AR41.10-P-0050-07SX	Mount front propeller shaft to transmission		
---------------------	---------------------------------------------	--	--

**Modification notes**

P41.10-2006-01

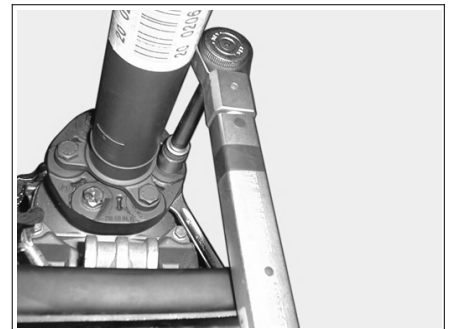
29.6.10	Value modified: Self-locking nut of flex disk to transmission or front propeller shaft, M12		*BA41.10-P-1001-01H
---------	---------------------------------------------------------------------------------------------	--	---------------------

Number	Designation		Model 216	Model 221
BA41.10-P-1001-01H	Self-locking nut of flex disk to transmission or front M12 propeller shaft	Nm	68	68
